**Meeting:** 3/16/2022  
**Project:** the Outpost  
**Applicant:** Michael Schmidt

**Location:** 808 State St. **Parcel ID** 95 I D 021  
**Zoning:** DK (Downtown Knoxville)  
**Description:**

Level II Major Alteration of an Existing Building/Structure  
Exterior rehabilitation and additions to an existing building.

**2-A-22-DT**

**1 FRONT FACADE**  
A3.2  
1/4" = 1'-0"

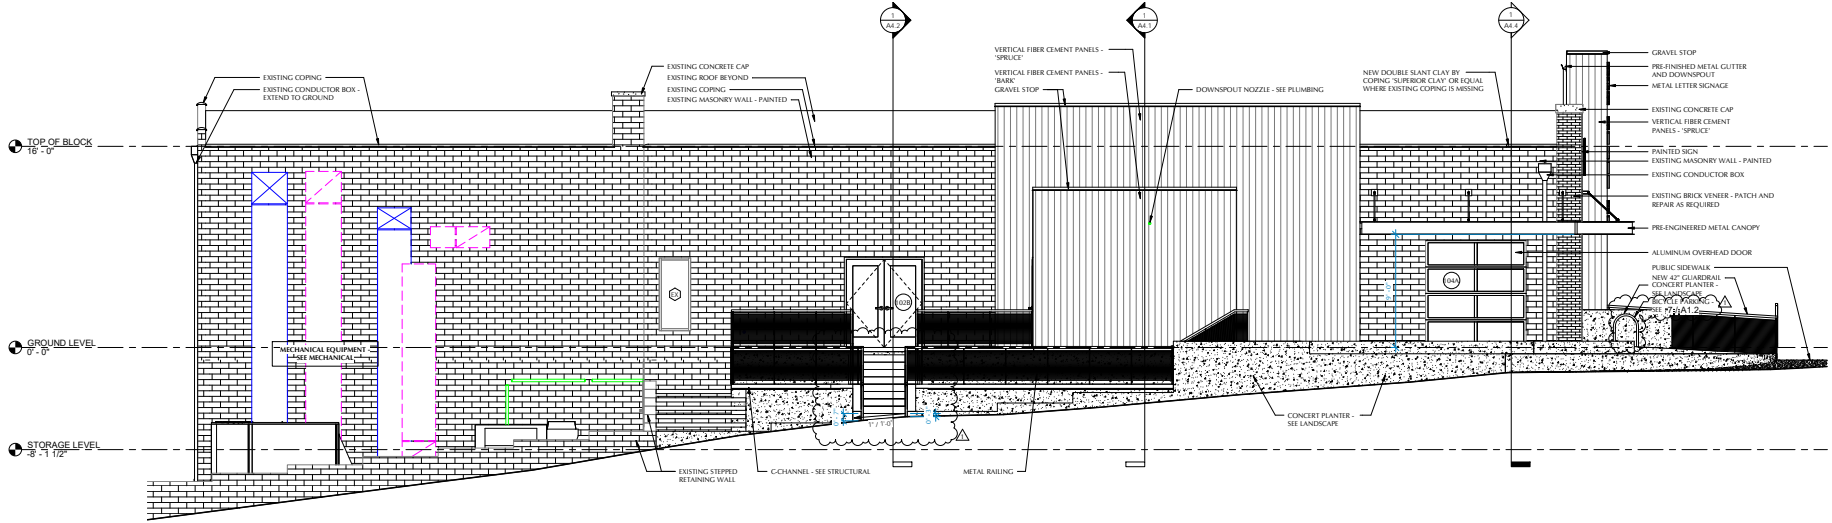
In general, exterior rehabilitation scopes meet the design guidelines. Driven by both seismic upgrade requirements and programmatic goals (locating the stage along the façade instead of to the rear of the building), the applicant has proposed to enclose the majority of the windows and reduce the amount of transparency along the façade. The Design Standards of the DK-G zoning district (Section 5.5.C, Table 5-4) require a minimum transparency of 30% on the ground floor of a front façade. The applicant is proposing to reduce the transparency to 15.23%.

The proposed windows and doors to be removed are not original to the building, though the original size of the fenestrations is visible in the openings to be infilled or covered with the fiber cement panels. Design guidelines recommend "enhancing pedestrian interest" by "creating a largely transparent and consistent rhythm of entrances and windows," and recommend "avoid[ing] blank walls along street-facing elevations."

Approval of the large reduction in transparency on the street elevation is pending Board of Zoning Appeals approval on 3/15/2022 (3-A-22-VA). The Board should discuss the enclosure of window and door openings on the façade in comparison with the guidelines.

- 1) Receiving the necessary variances at the 3/15/2022 BZA meeting, and pending Board's approval of the removal of façade ground floor transparency;
- 2) Minimize visual impact of mechanical equipment on north/right elevation via screening or paint;
- 3) Meeting the relevant standards of City zoning code for landscaping (Article 12);
- 4) Meeting the relevant standards of the City sign code.

L1.1

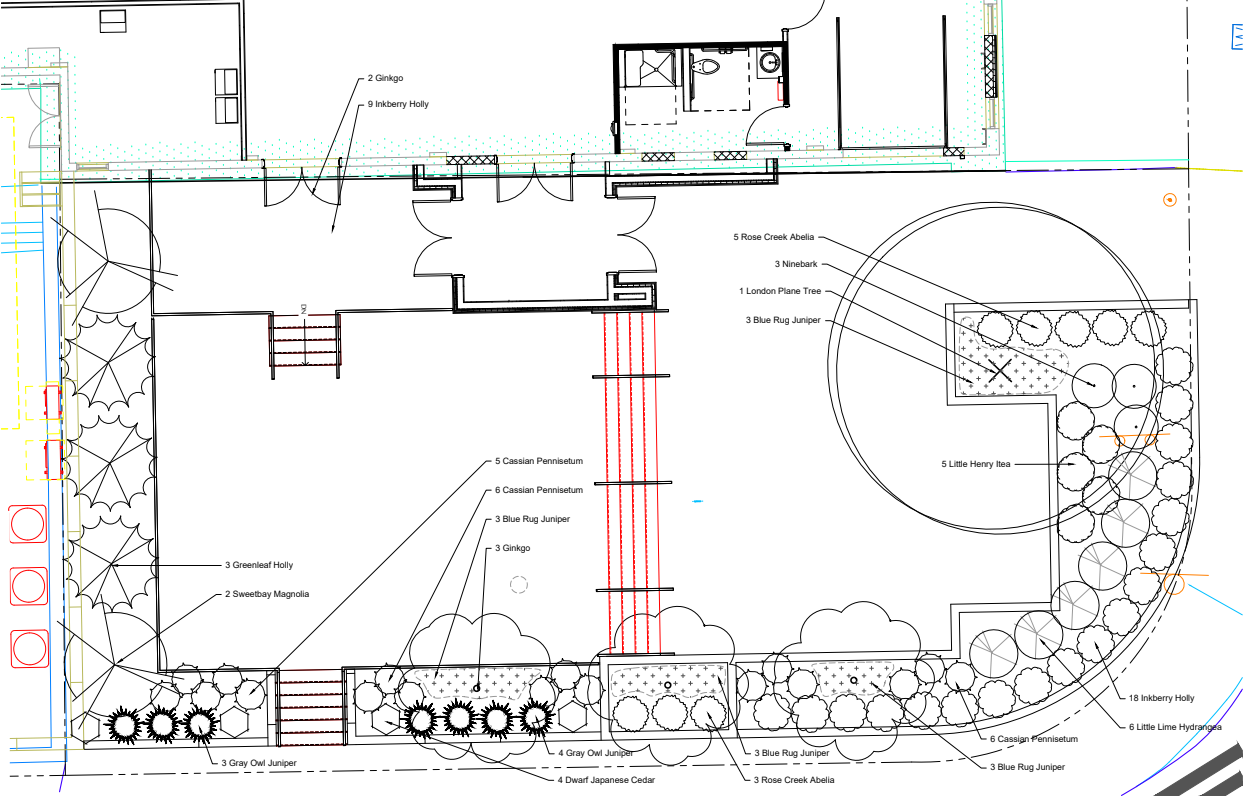
The proposed landscape and patio areas meet the design guidelines for downtown beautification, along with creating pedestrian-friendly private plazas with extensive landscaping. The proposed grade separations on the patio correspond with the site's existing topography, and the plaza will be accessible via a stair off the Cumberland Avenue elevation.
